**Committee of Experts on the Transport of Dangerous Goods
and on the Globally Harmonized System of Classification
and Labelling of Chemicals**

**Sub-Committee of Experts on the
Transport of Dangerous Goods**

**Revision of the Manual of Tests and Criteria:
Part I: Sections 10 to 17**

**Transmitted by the Chairman of the Working Group on Explosives on
behalf of the Working Group**

Figure 15.4.1.1: CAP SENSITIVITY TEST (using steel witness plate)

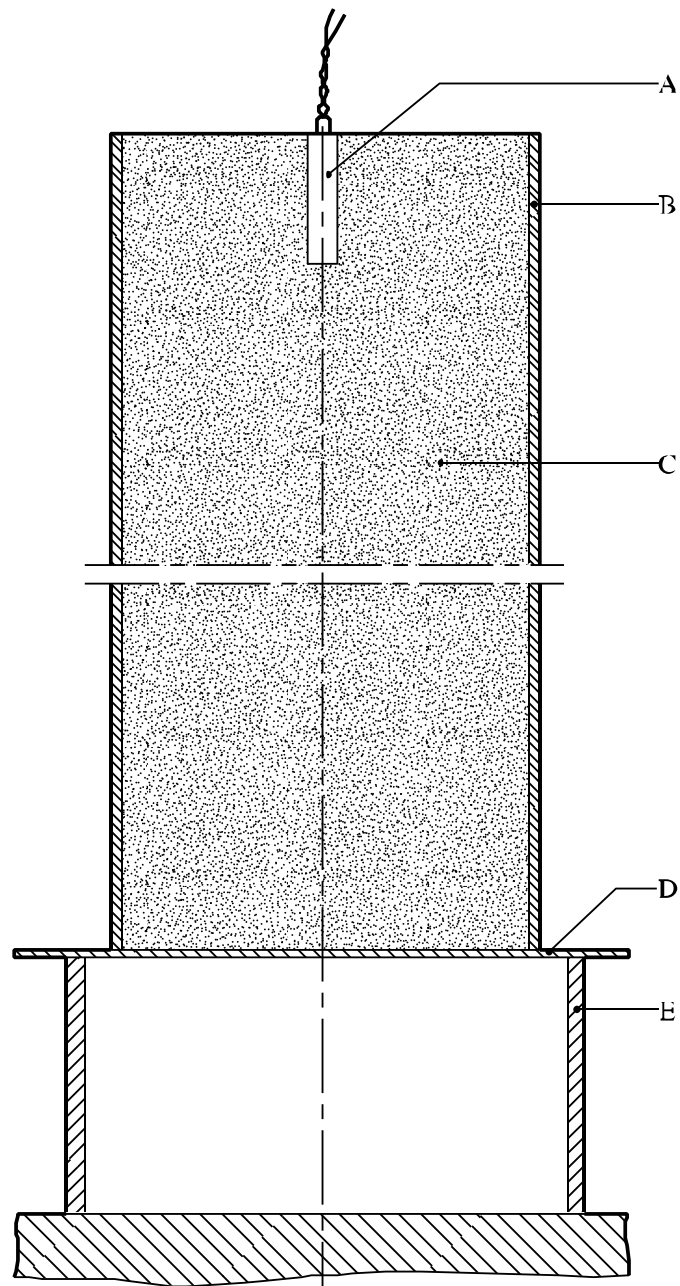
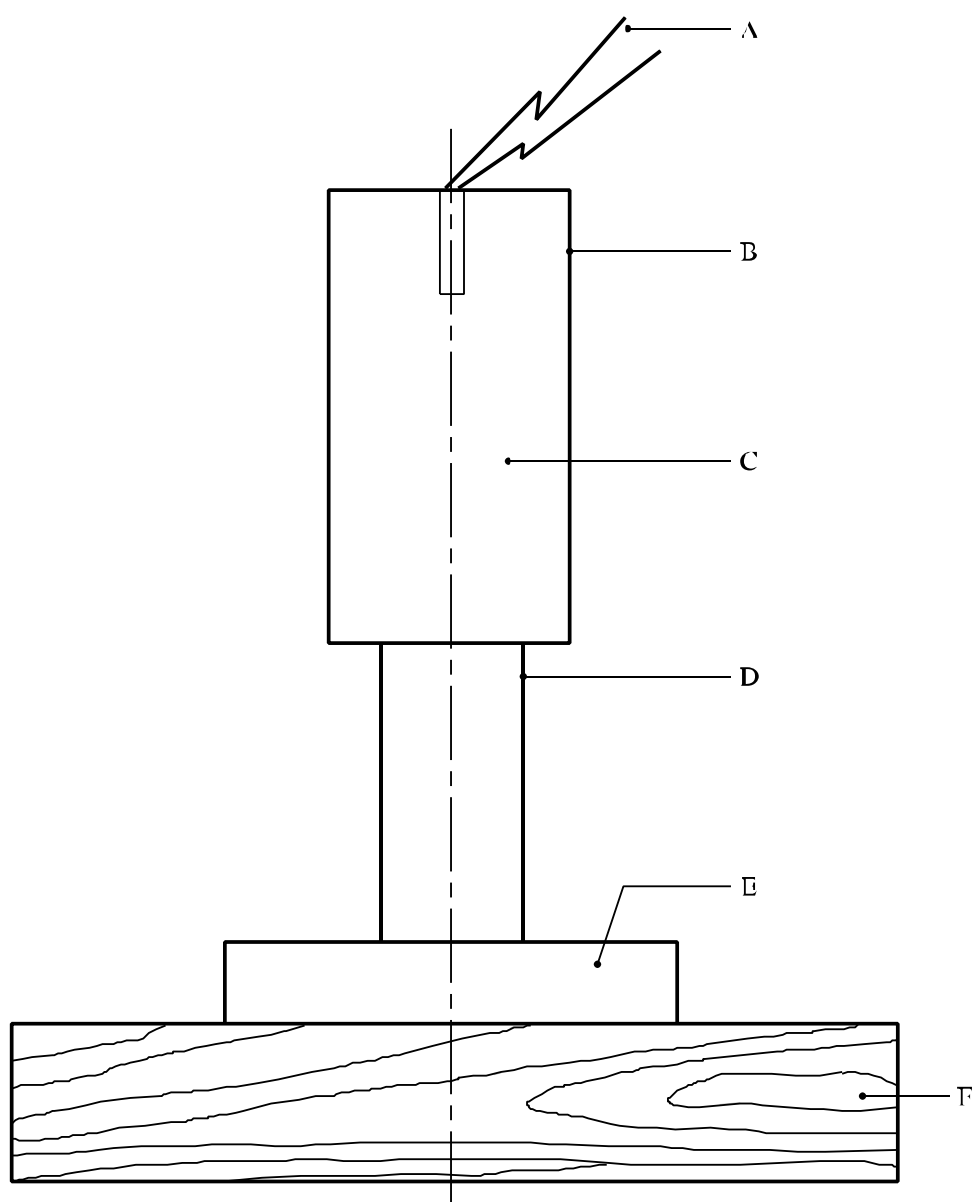
- (B) [Cardboard tube](#) ~~fibreboard spirally wound plys~~
Witness plate of normal structural steel
-
